STAFF REPORT 09-11-2019 REGULAR MEETING APPLICATION NUMBER: 19-6416 VIOLATION NUMBER: 19-314 ADDRESS: 2475 EDISON STREET HISTORIC DISTRICT: BOSTON EDISON APPLICANT: THEODORE MCNEAL DATE OF COMPLETE APPLICATION: 8-26-2019 STAFF SITE VISIT: 08-30-2019

SCOPE: ERECT NEW REAR PORCH AND DECK

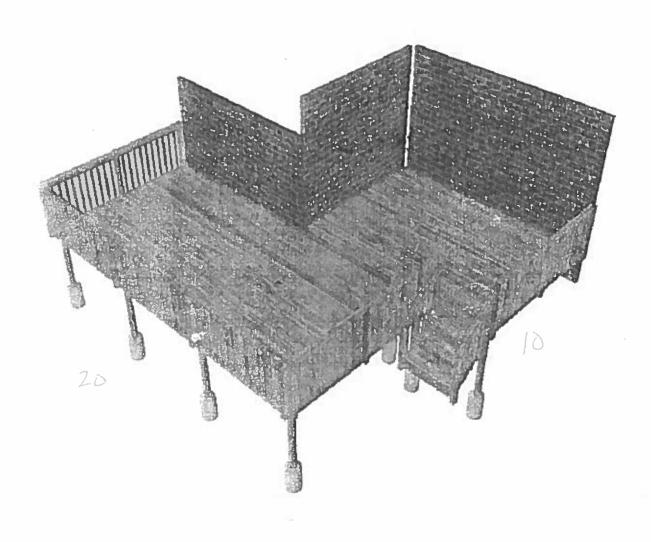
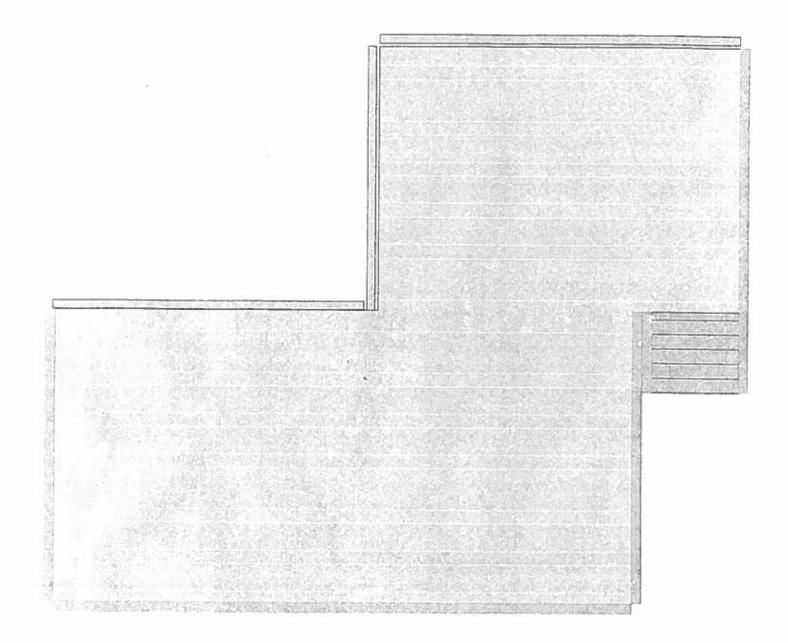
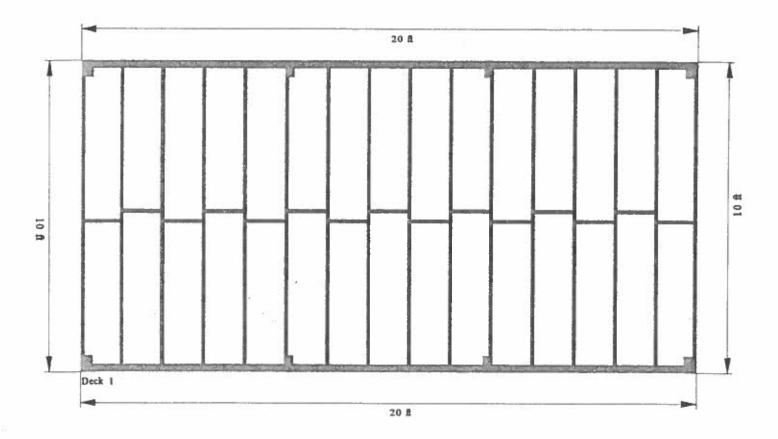
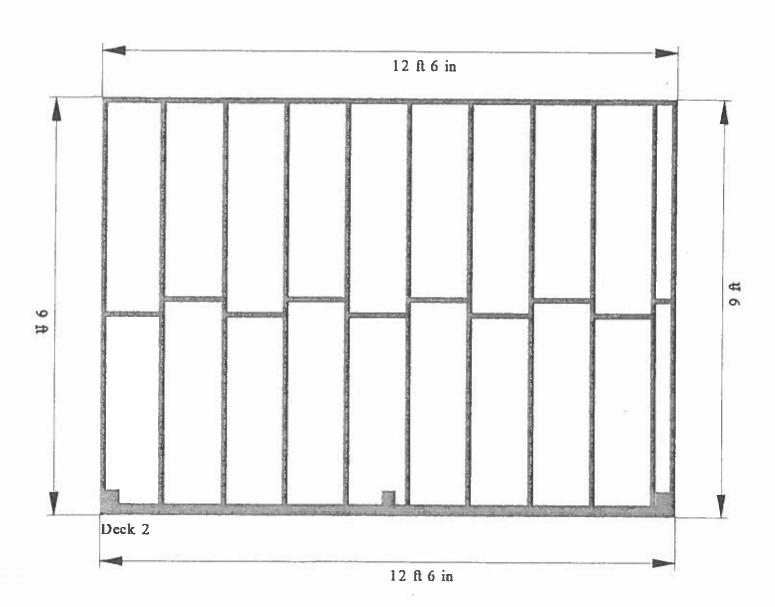
- Regarding the deck design—there are discrepancies (stair location and height of deck area vs. porch) between the Home Depot contract documents and the drawings provided by the applicant.

- Applicant to submit accurate and finalized drawing of what is currently being constructed for staff review and approval prior to issuance of COA.
- Applicant to submit specifications of proposed finish for both the deck area and two-story porch for staff review and approval prior to issuance of COA. Finish to be compatible with existing house.
